**Livingston County
Water and Sewer Authority**

**Leicester/York Regional Water Supply
Expansion
Engineering Report Amendment #1**

March 2024

DWSRF Project No. 19225

MAP SHEET:
Scenario 7C

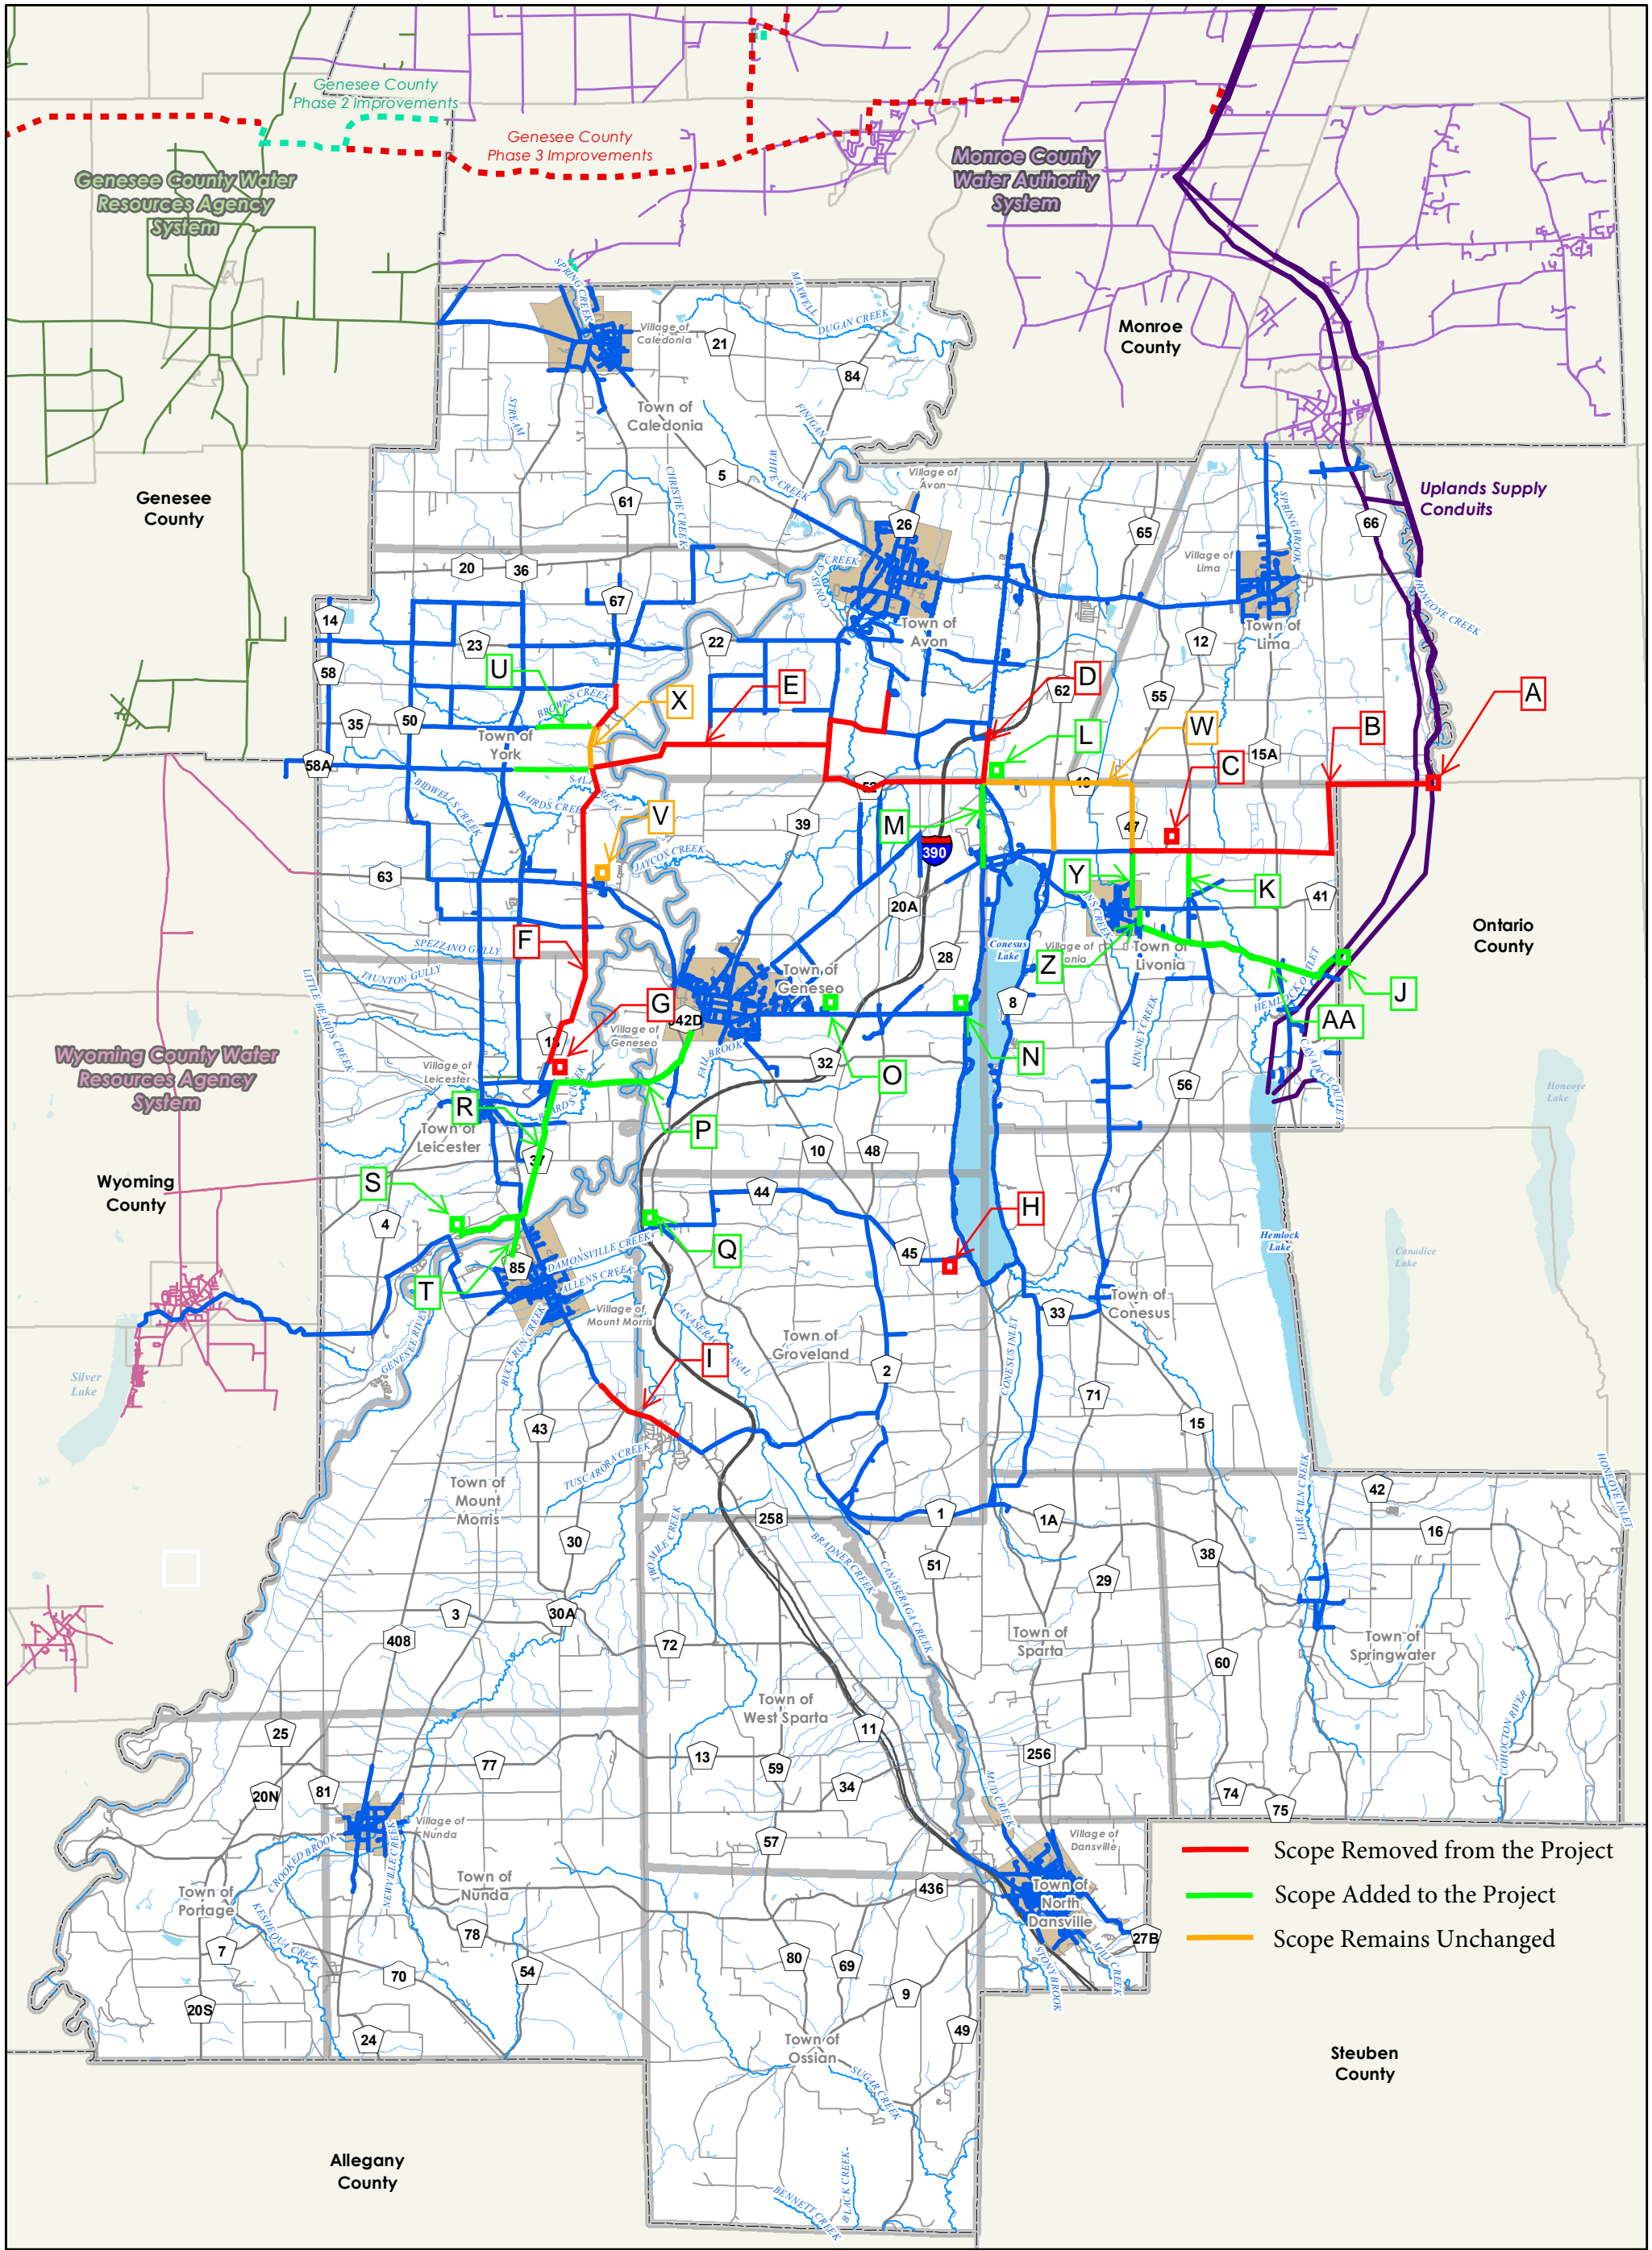
- **A and B** (New Lima PS and transmission line) are replaced by **J, AA, K, Y and Z** (Upgrade to Hemlock PS, replacement and upsize of transmission line along Big Tree Rd, East Ave., Summers St. and Livonia Center Rd) and **N and O** (Improvements to the Village of Geneseo Water Plant and interconnection to increase pumping capacity and volume to plant, and TTHM removal system installed for the Village of Geneseo water storage tank (3MG)). These revisions achieve the same outcomes as the originally proposed project by ensuring increased access and availability of additional water capacity to the impacted communities and the region. These revisions also include the addition of the Village of Geneseo and Town of Geneseo as partners.

- **C** (New LCWSA 4MG water storage tank) is replaced by a new LCWSA 3MG water storage that is currently under design and covered under Project No. 18746. Project No. 18746 was originally intended to be a 2MG tank but has been increased to 3MG to provide additional water storage for regional partners.

- **W** (Water transmission lines along Bronson Hill Rd., Poplar Hill Rd. and S. Lima Rd.) remain the same as the originally proposed project but will be fed from the Hemlock PS and new LCWSA water storage tank instead of the Lima PS.

- **D** (Town/Village of Avon interconnection and Avon water storage tank improvements) is replaced with **L** (which is just the Town/Village of Avon interconnection). The Avon water storage tank improvements will be completed under a separate project currently under design by the Village of Avon, Project No. 19550.

- **E** (River Rd. transmission line) is replaced by **M** (Rt. 256 transmission line) which will connect to existing LCWSA infrastructure to provide increased volume to the Village of Geneseo Water Plant for distribution to the impacted communities.

- **X** (River Rd. transmission main) will remain the same as the originally proposed project. **U** (additional transmission main) will be added to provide residents that do not have water due to the impacts of the salt mine collapse.

- **V** (New York PS) remains the same as the originally proposed project.
- **F** (River Rd. North water transmission main) is replaced by **P** (Rt. 63/20A transmission main) providing a water supply connection to the Town of Leicester which is an impacted community.

- **G** (New 0.50MG Leicester water storage tank – replacing the existing 0.45MG water storage tank) remains the same as the originally proposed. The location, however, will change to **S** (inside Letchworth State Park) and the tank will be upsized to 0.75MG. The new tank will also include a TTHM removal system and will support the Town of Leicester and Letchworth State Park; both currently have EPA Administrative Orders for high TTHM.

- **I** (Rt. 36 transmission main) and **H** (Maple Beach PS improvements) are replaced by **R** (River R. South and Park Rd. transmission mains) as they will provide water to the Village and Town of Mt. Morris. **R** will also provide water to Letchworth State Park to address current water quality and fire flow issues.
- **Q** (piping improvements) combined with **R** will provide two (2) separate 12-inch redundant water transmission main connections to the Town and Village of Mt. Morris.
- **T** (Murray Hill transmission main) is an addition to the project that will provide water to the Livingston County Nursing Home to address current water quality and fire flow issues.
